Analysis of EU policy proposals for DG ENER Lot 12 Commercial Refrigeration

Including comparison with policy thresholds and product data from other regions

21 August 2014

Figure 13. EU proposed MEPS and energy label classes for vending machines.

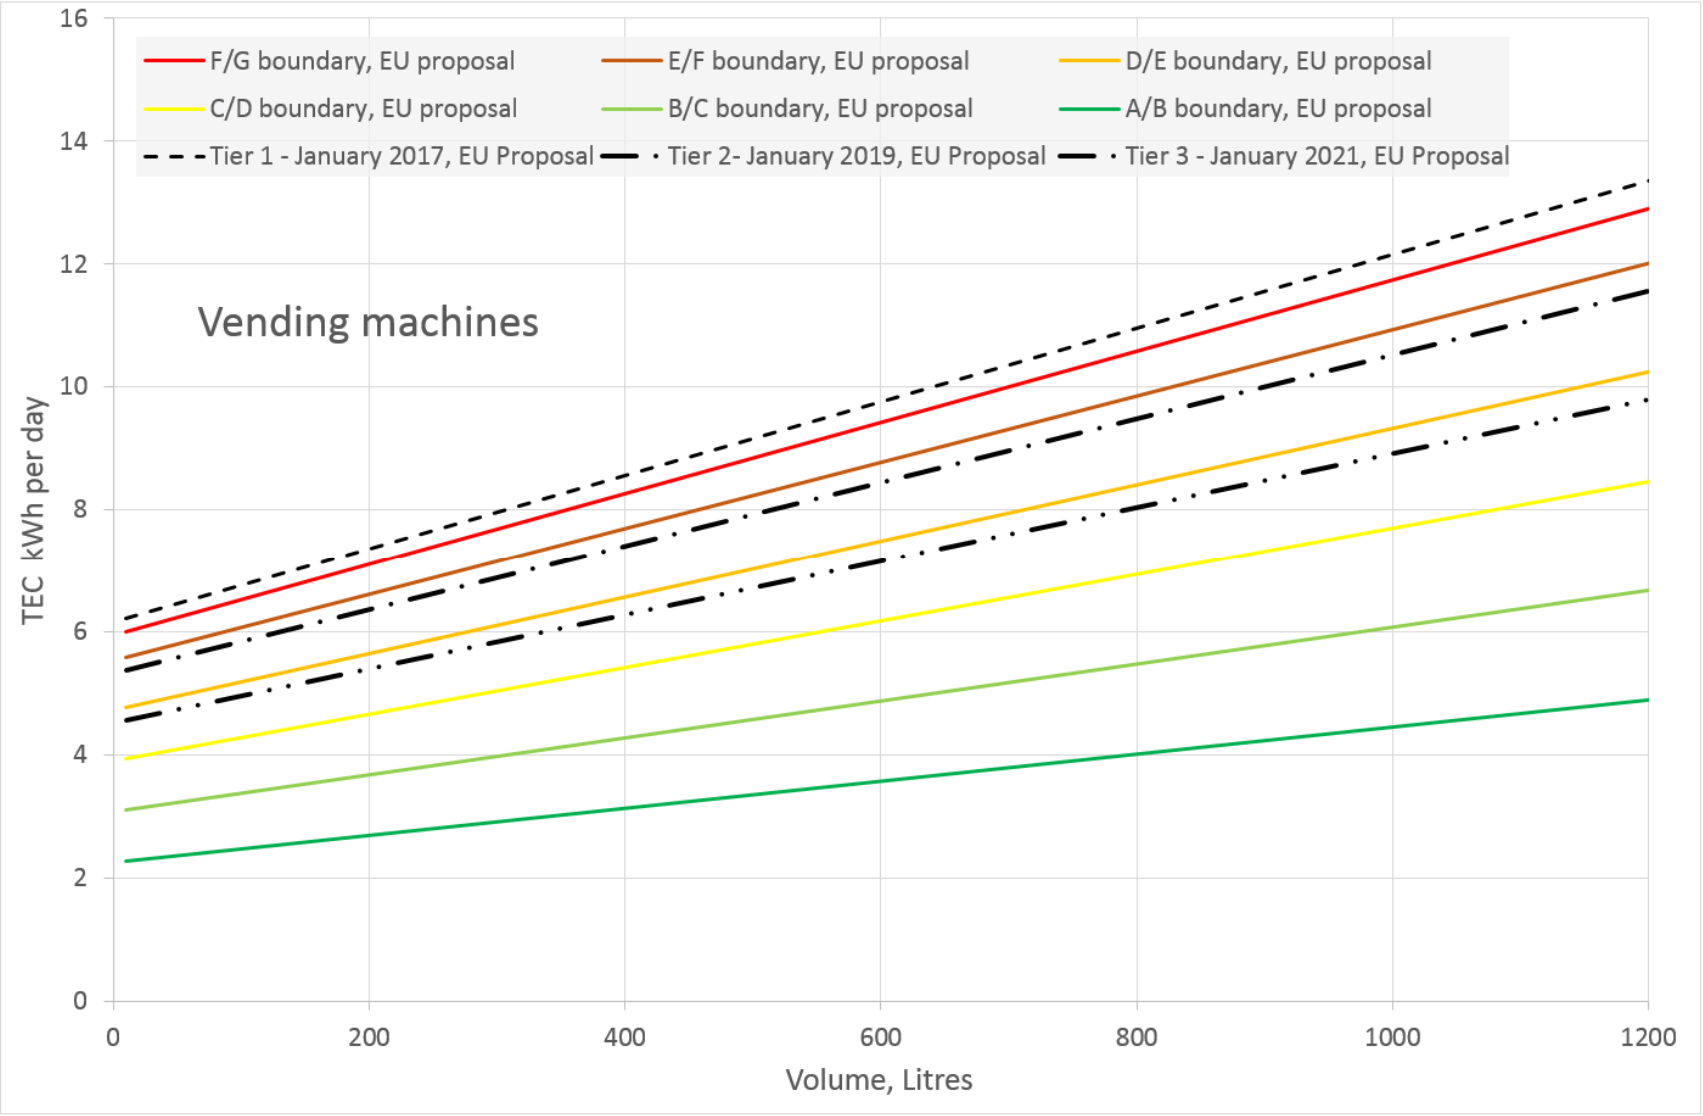
1. From Figure 13, the proposed EU MEPS do not coincide with any label levels – this is potentially confusing and appears unnecessary since MEPS could be aligned with the G, F and E label levels.

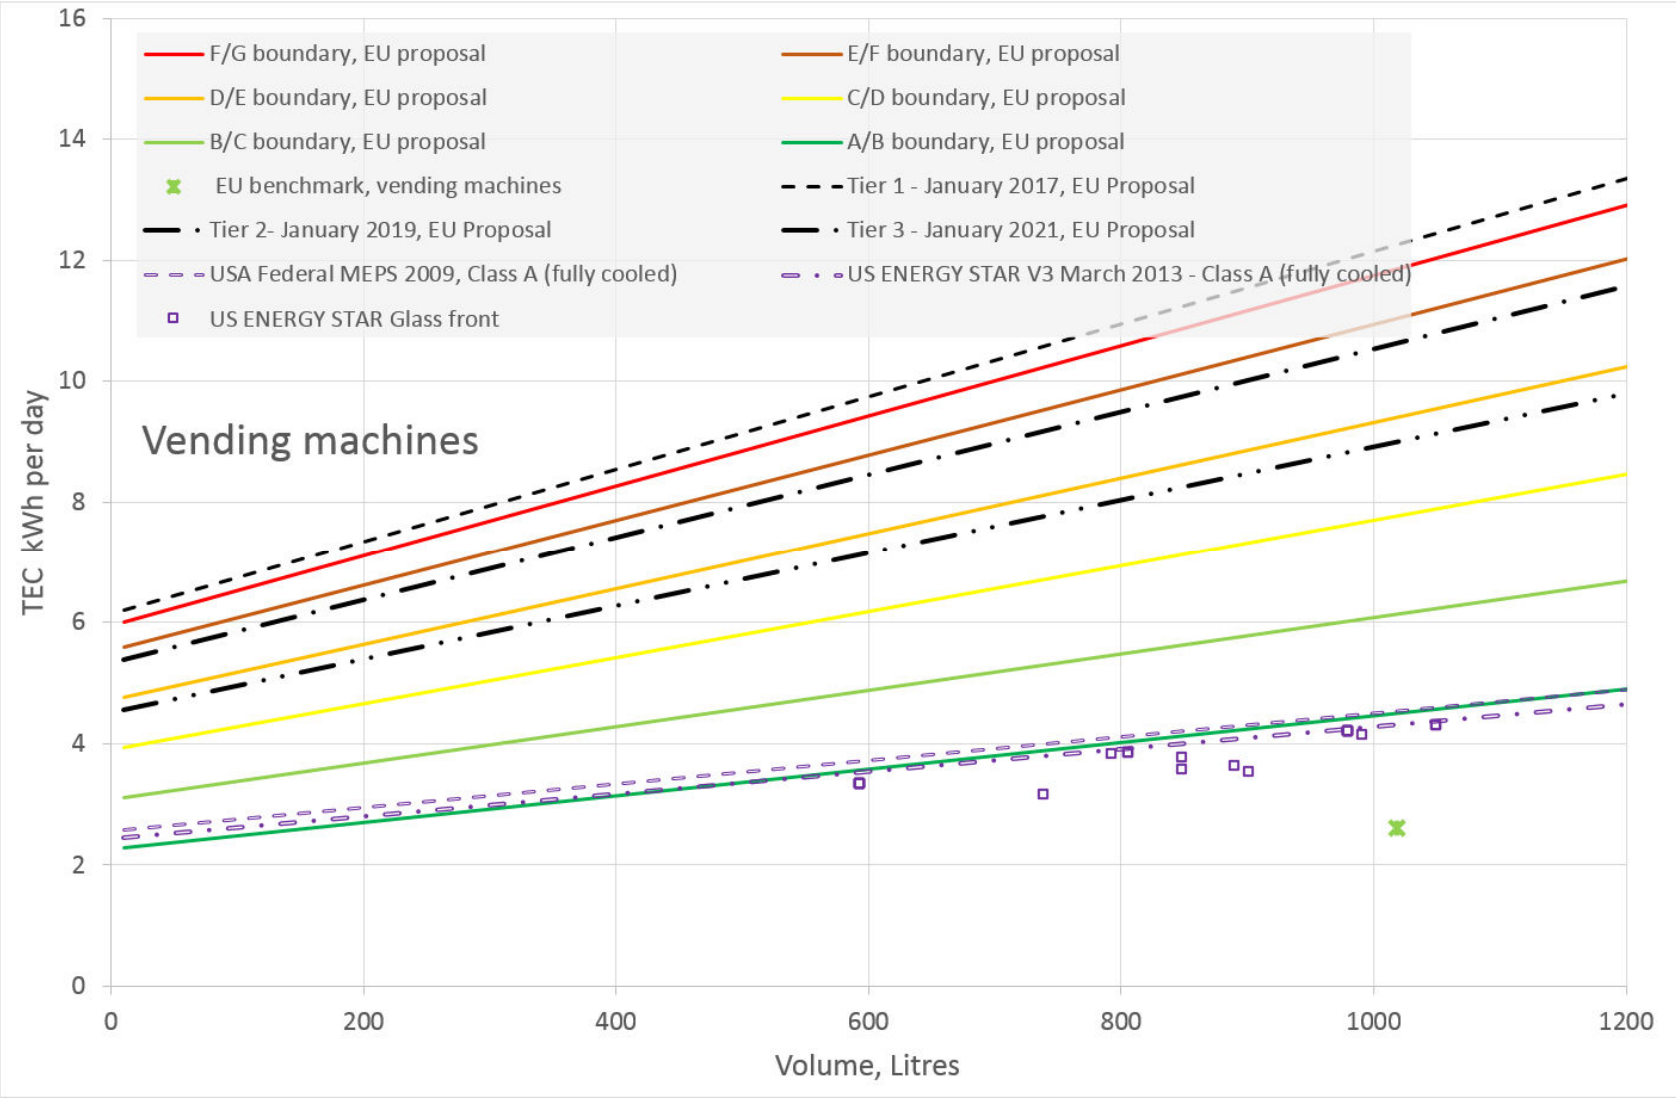
3. However, regarding stringency the EU requirements, even the 2021 requirements allow twice the energy consumption per day of US requirements that became effective in August 2012. The reason for this large difference is not clear, but may stem from the EU data set: JRC fitted the proposals with the EU data provided to them by EU manufacturers (see Figure 6.21 page 108 in the JRC preparatory study). However, the EU data covers several years and therefore may include data for legacy machines that are now obsolete and superseded by new machines that include numerous energy efficiency features. One EU machine was tested to the new EU draft test method, and that datum point is shown in Figure 15. This machine was regarded by the European Vending Association as typical of modern EU spiral vend machines[36] and was tested with an internal temperature of 12°C. This datum point is positioned alongside the US glass front machines and so would support the view that the EU proposal for vending machines is largely based on legacy data. It may be helpful to address this problem if the EU data set were filtered to include only machines entered into the EU market in the last 2 years.

4. All US ENERGY STAR V3 qualified glass front machines are EU energy label A. (Note: ENERGY STAR opaque front, partially cooled and not shown on this Figure for clarity of purpose and as these are less relevant to the EU market are EU label A or upper part of label B).

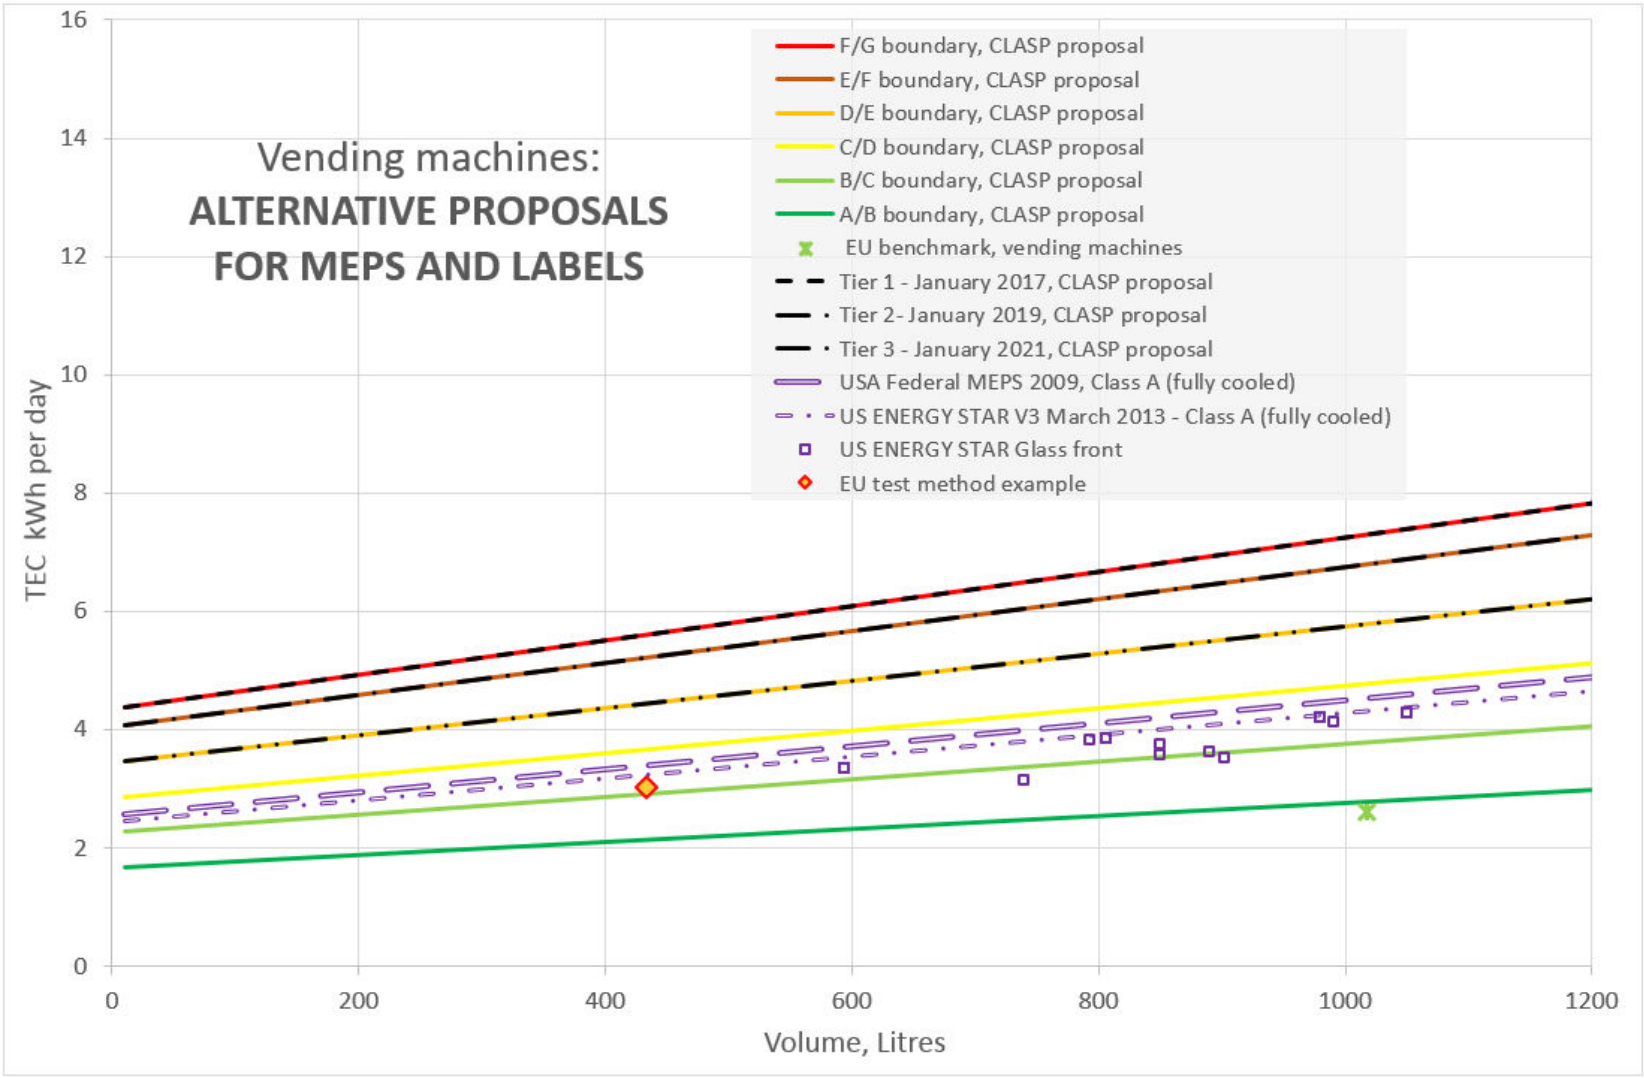
The apparent disparity in stringency between US and proposed EU regulations is surprising given that there is unlikely to be significant difference in the basic technologies employed (there are only around 20 manufacturers of vending machines globally outside of China[37]). Also, given the likelihood that the EU data includes legacy machines that are far less efficient than those currently on the market, an alternative proposal is made as Figure 15.

For the alternative proposal the distribution of labels is far more appropriate to cover the spread of the current products (leaving the legacy products in label G) and ensures differentiation of the best performing current models, with scope for future improvements. In addition, the MEPS align with the energy label classes to minimise confusion in the market and make market surveillance easier. The minimum requirements are much closer to the US MEPS, but are not as stringent to allow a period of grace for the EU market database to be developed. Regulatory review after 3 years is suggested to review the ambition of the Tier 2 (2019) and Tier 3 (2021) requirements.
